ADDENDUM NUMBER TWO

Indiana University Launch Accelerator for Biosciences 1302 Indiana Ave. Indianapolis, IN 46202

Addendum Dated: OCT 21, 2025

IU Project #: 20250072 BSALS Project #: 00360481

SITE UTILITY PLAN

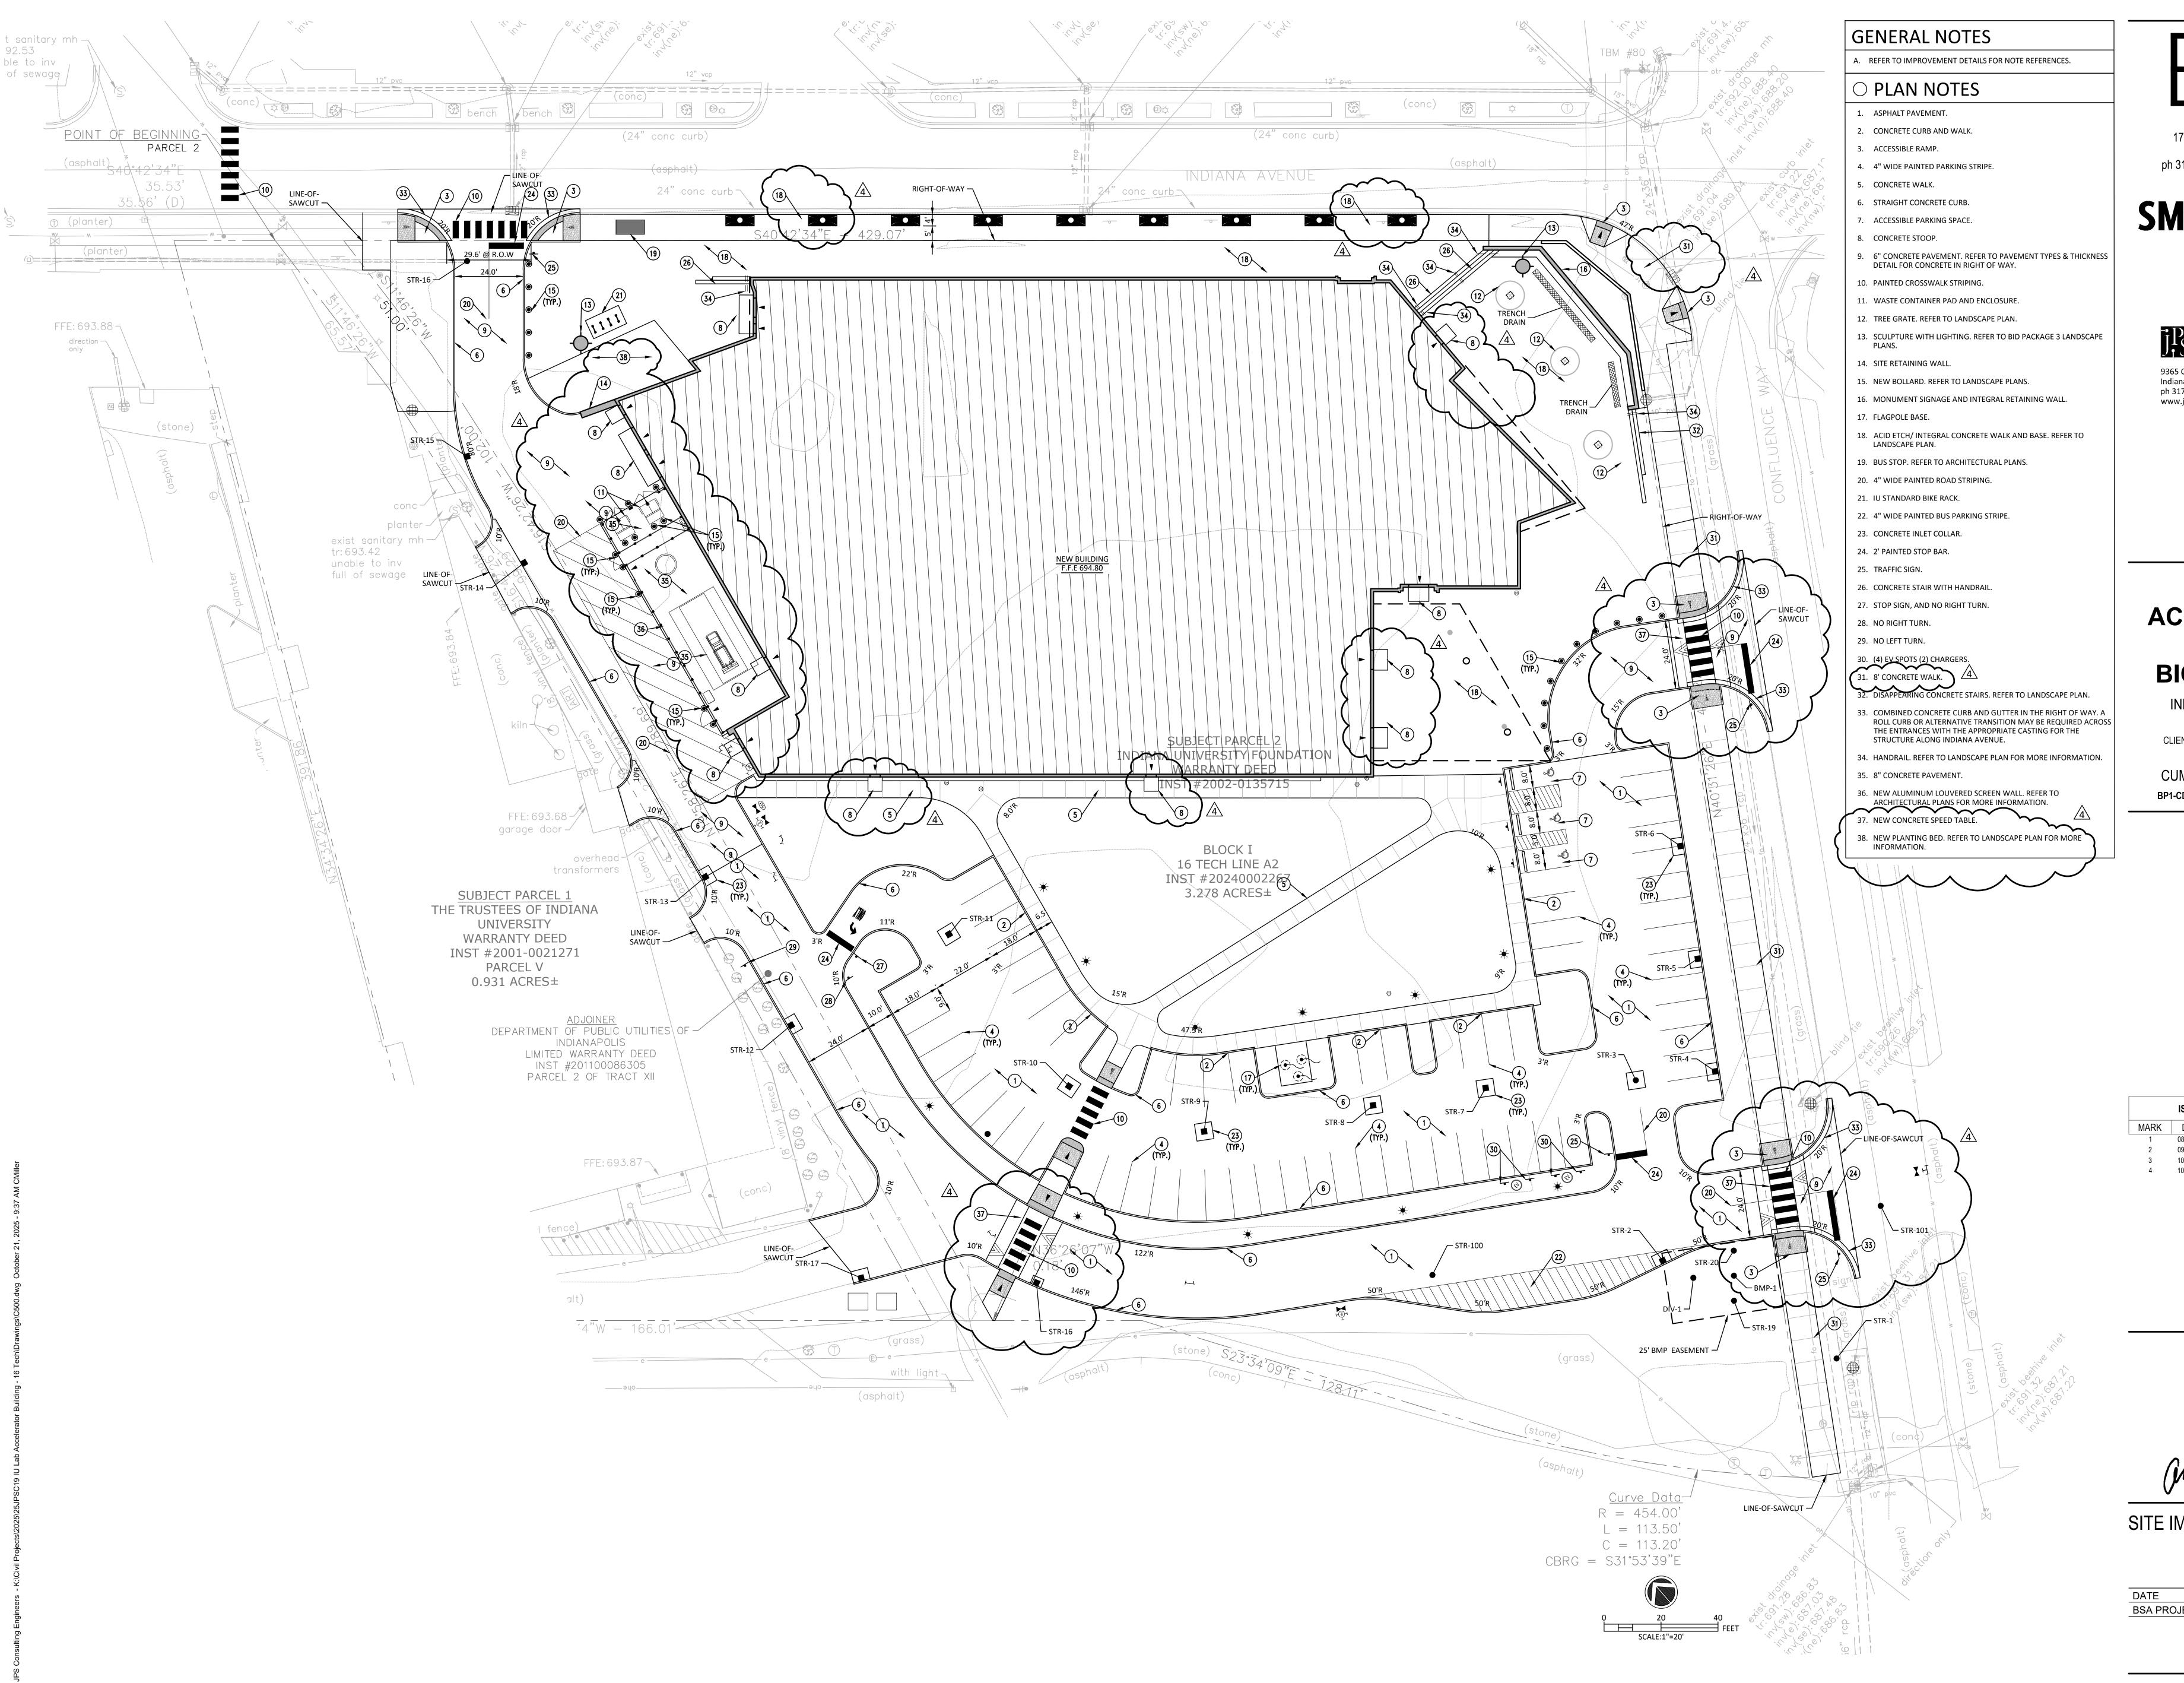
- a. Revise the gas meter location as shown on the clouded portion of the attached revised drawing.
- b. Revise note #28 as shown on the clouded portion of the attached revised drawing.

SITE IMPROVEMENT PLAN

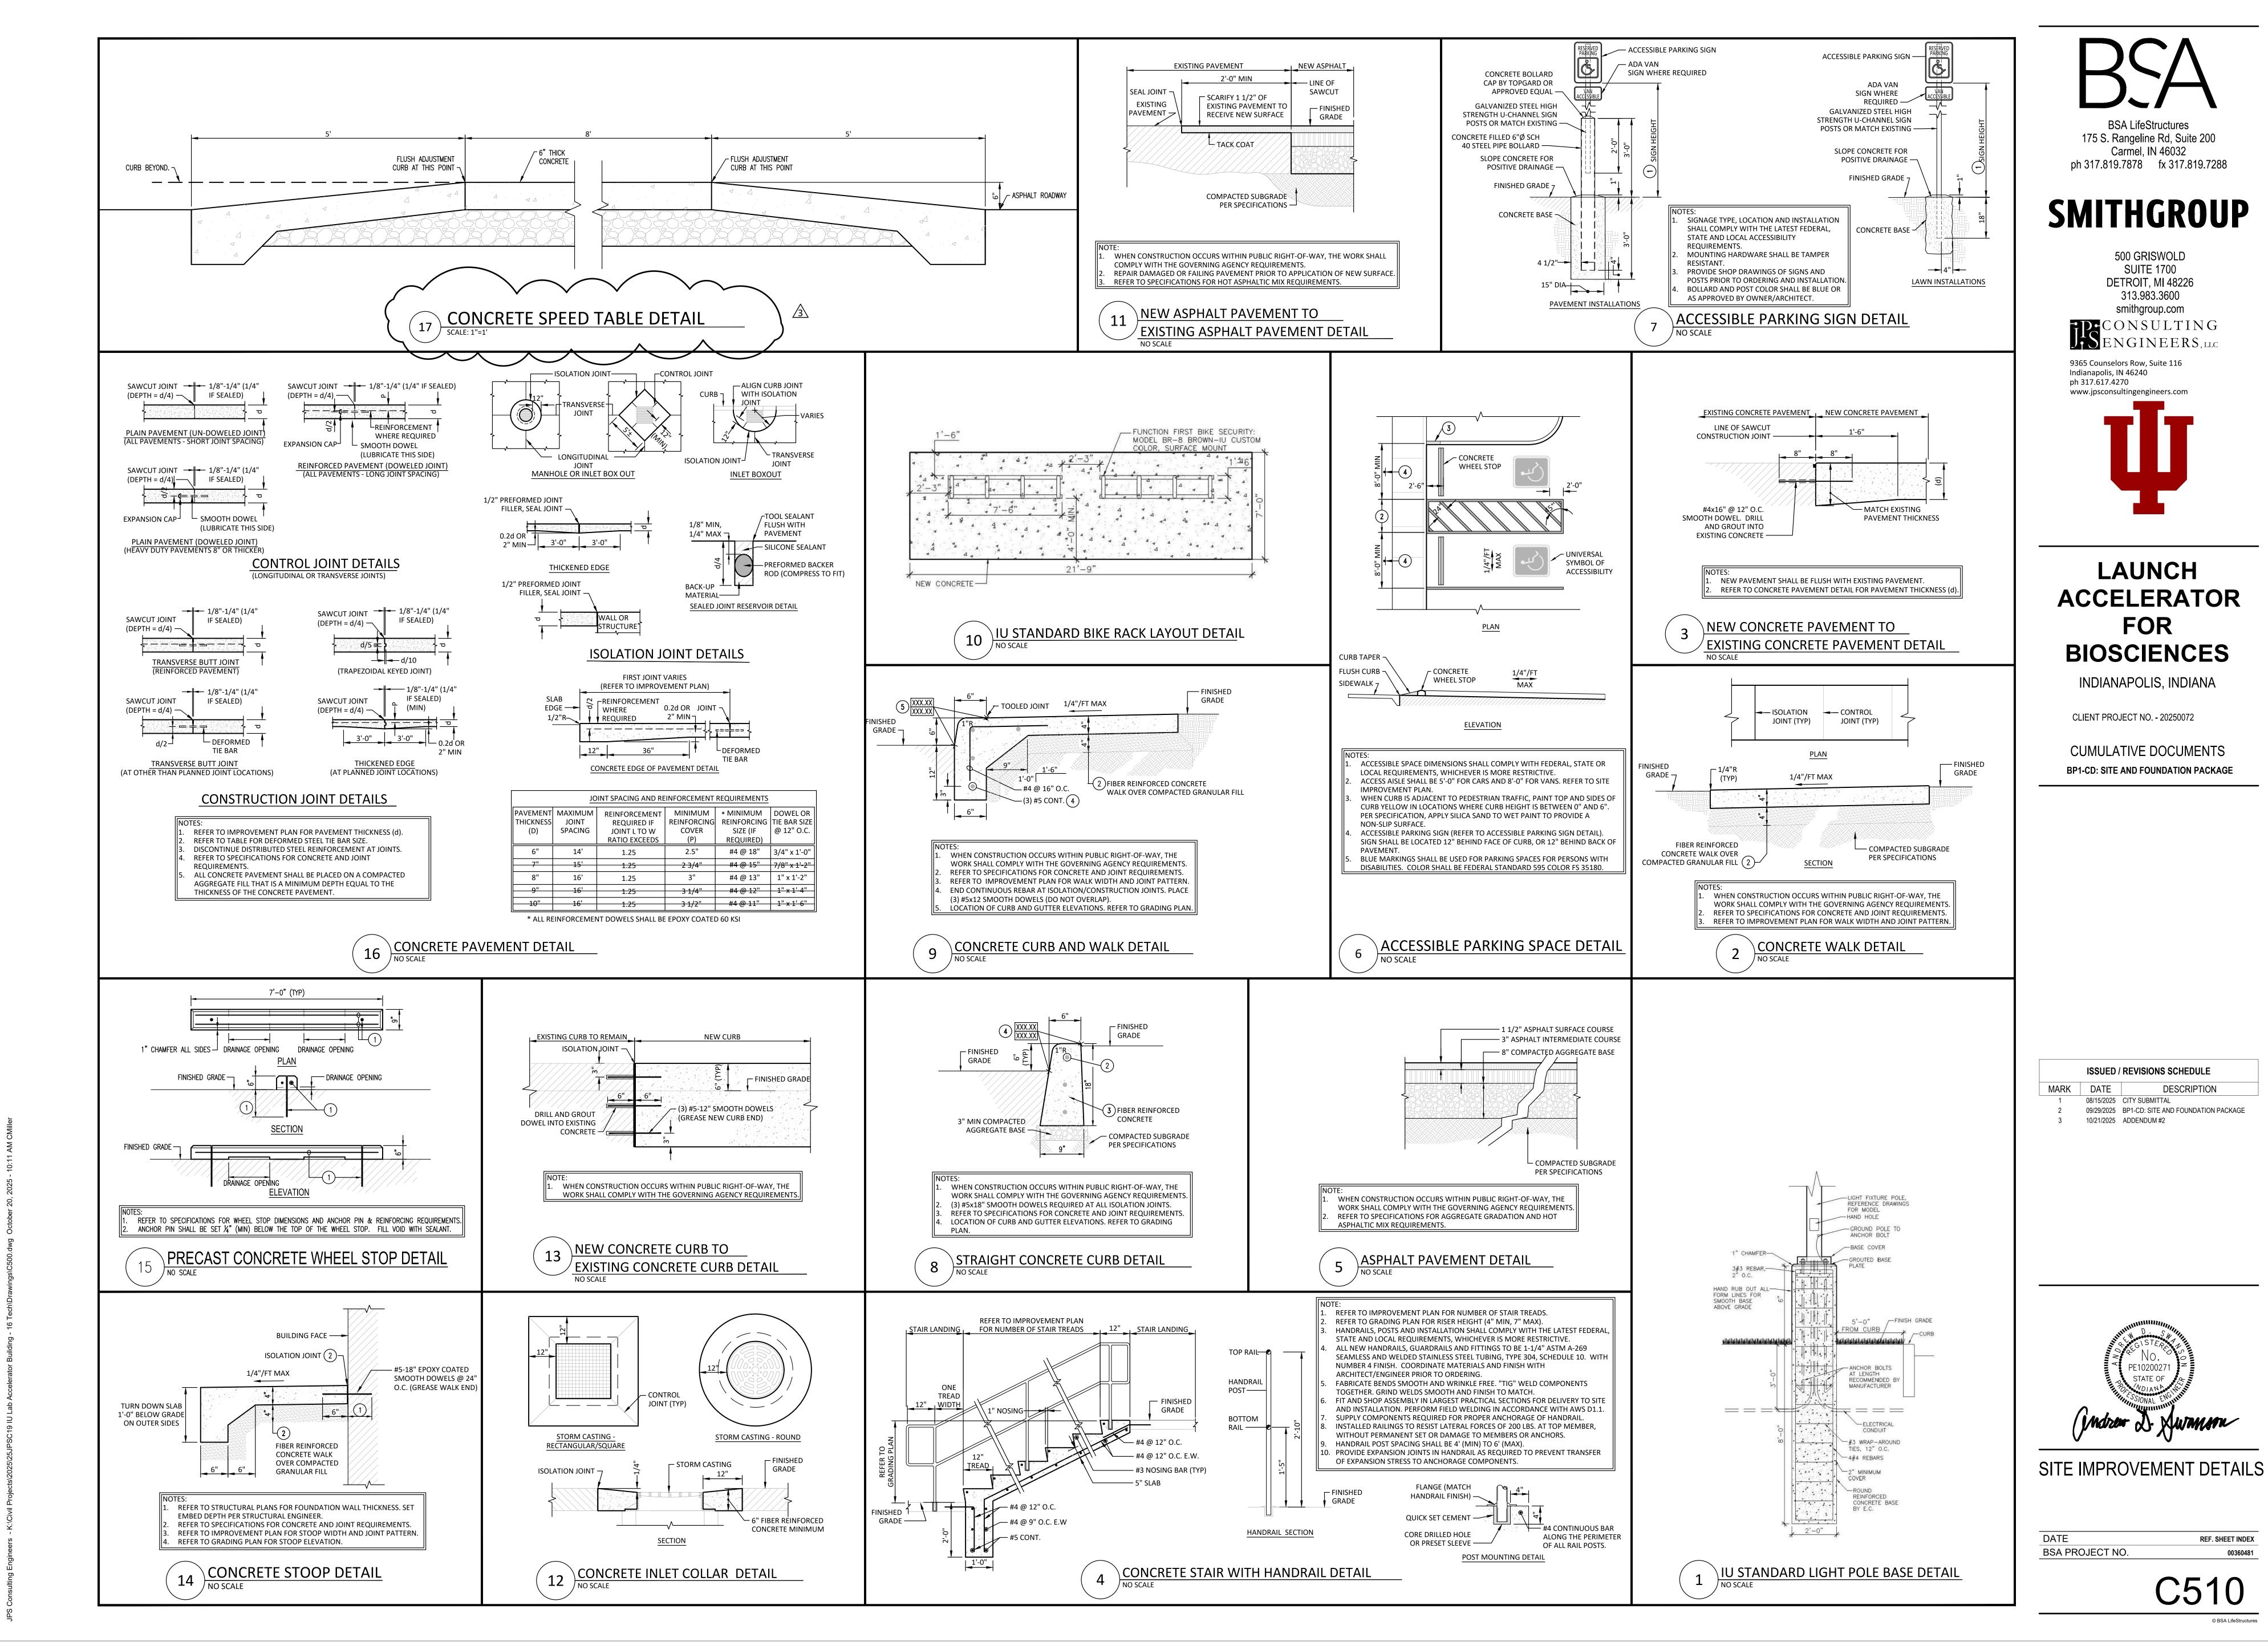
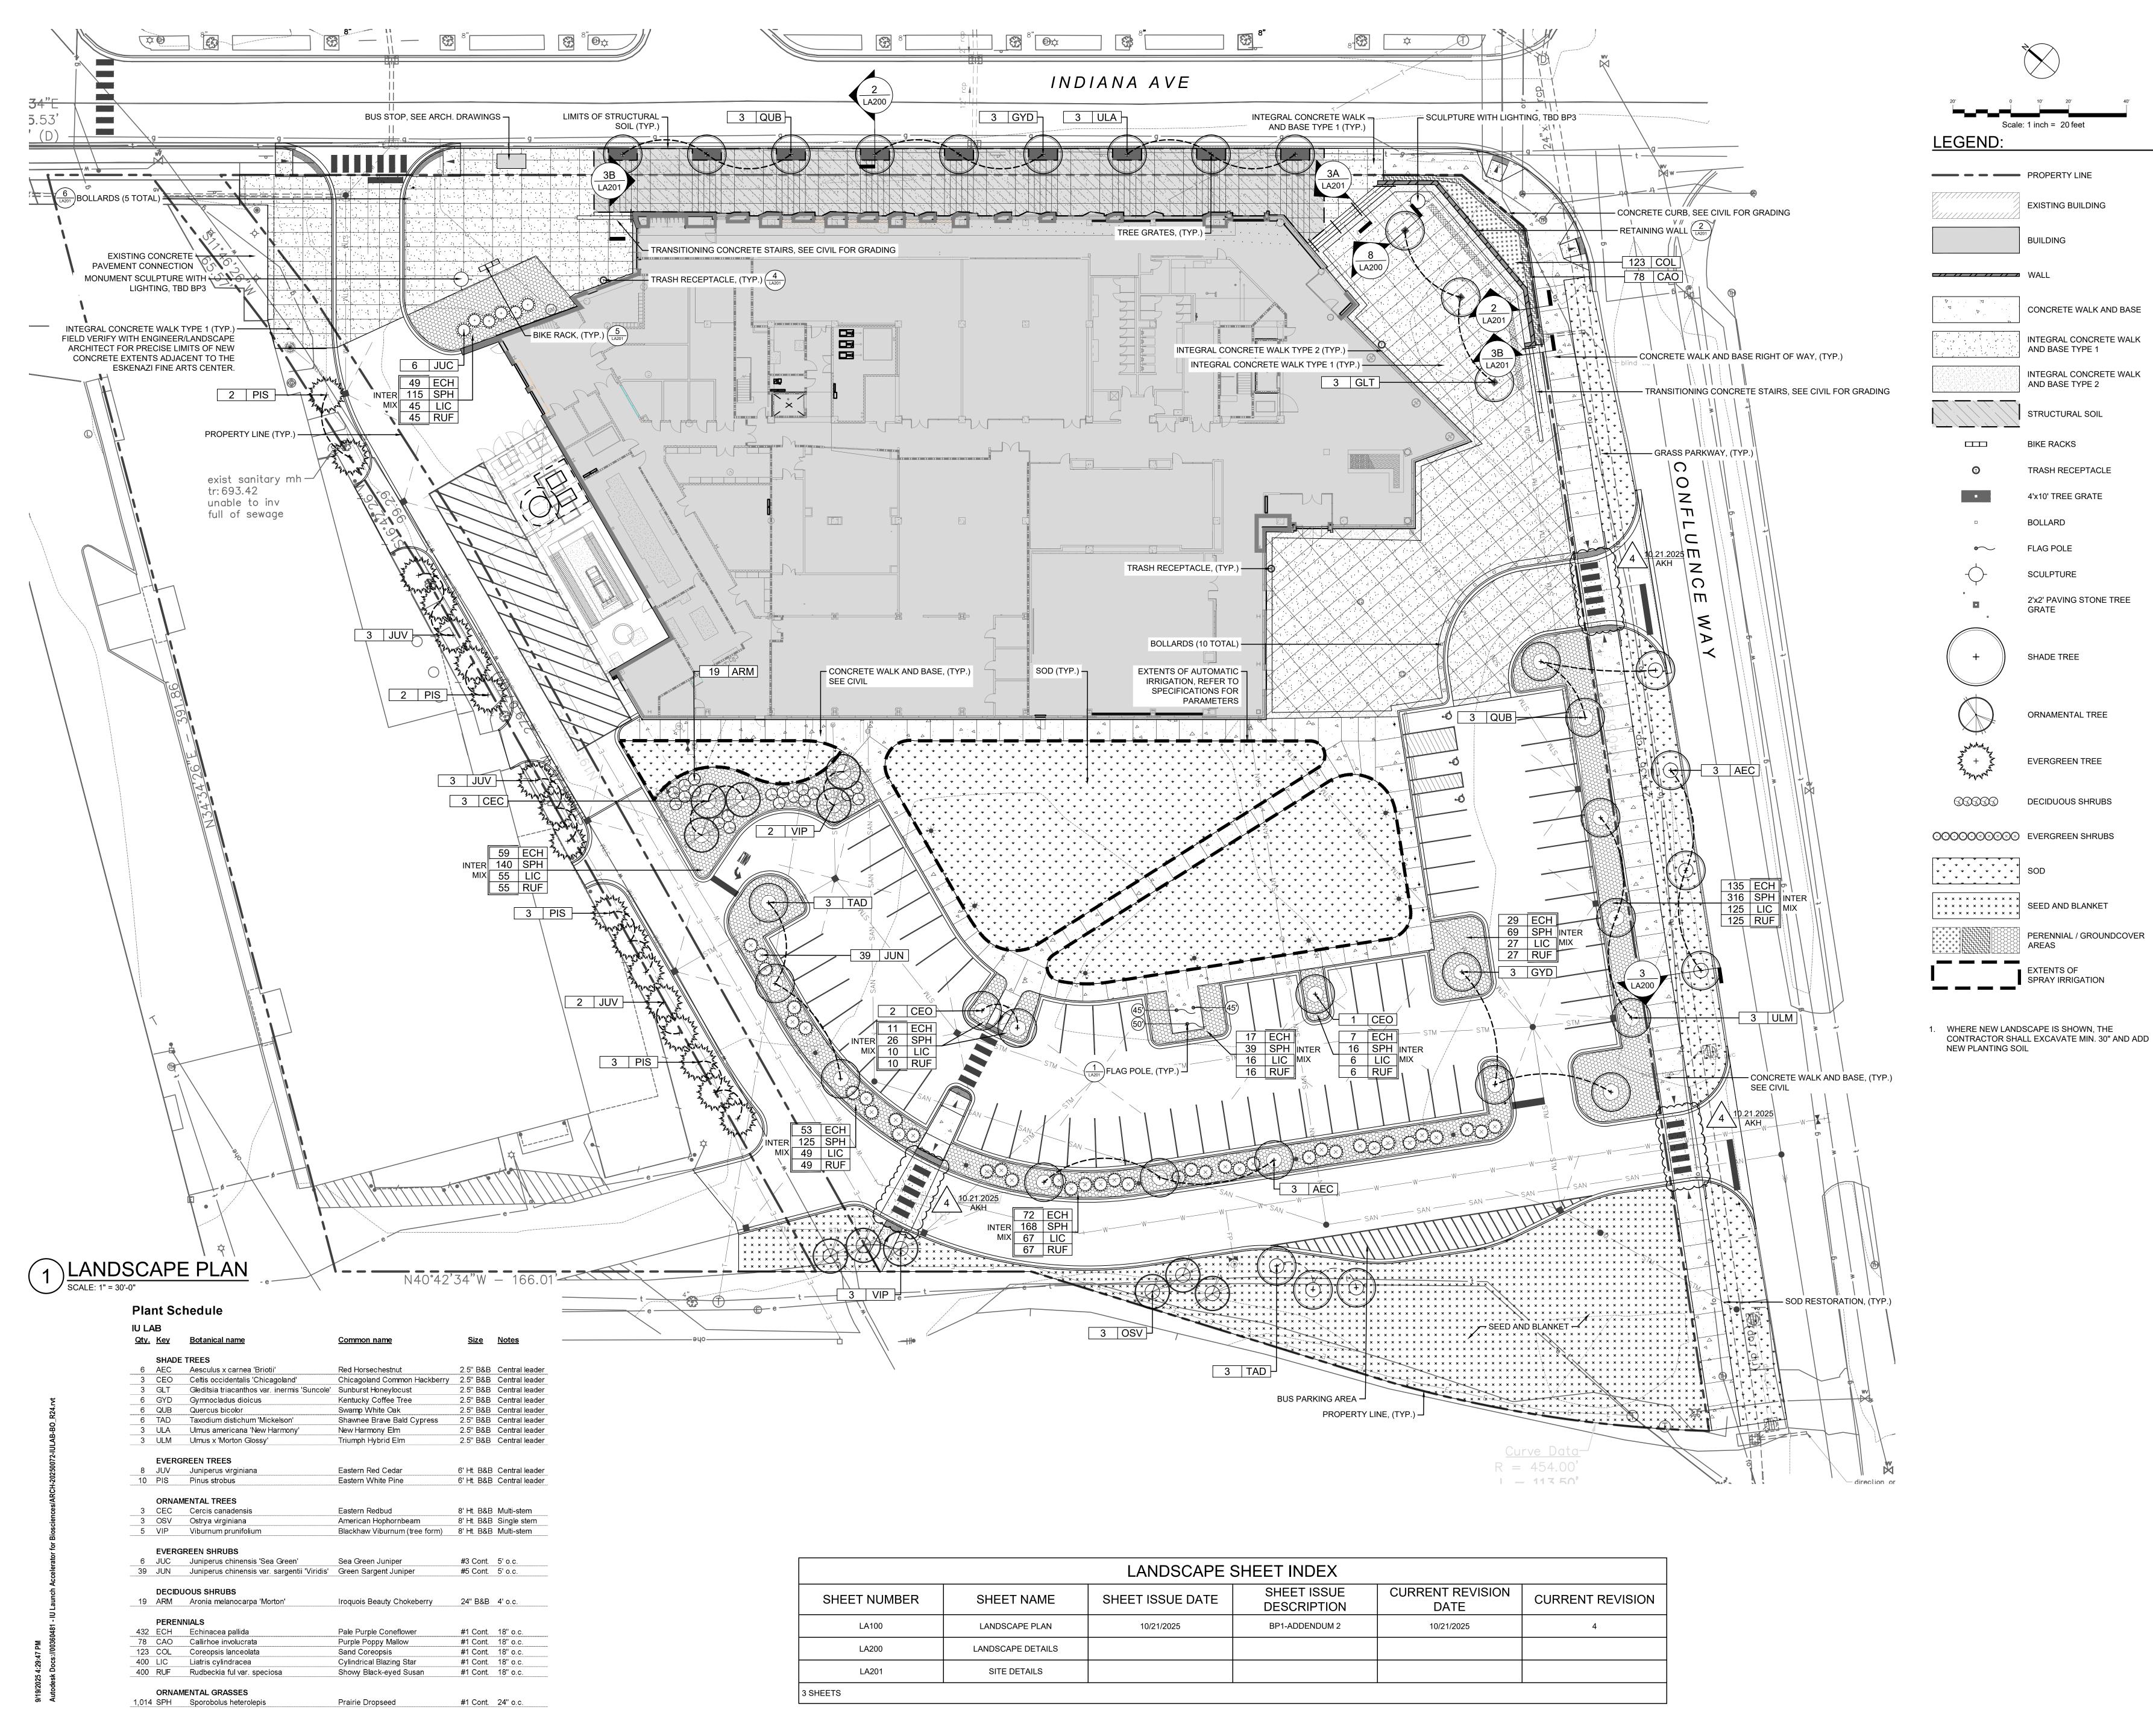
- a. Revise the MEP yard layout as shown on the clouded portion of the attached revised drawing.
- b. Add speed tables at pedestrian crossings as shown on the clouded portion of the attached revised drawing.
- c. Revise the notes as shown on the clouded portion of the attached revised drawing.
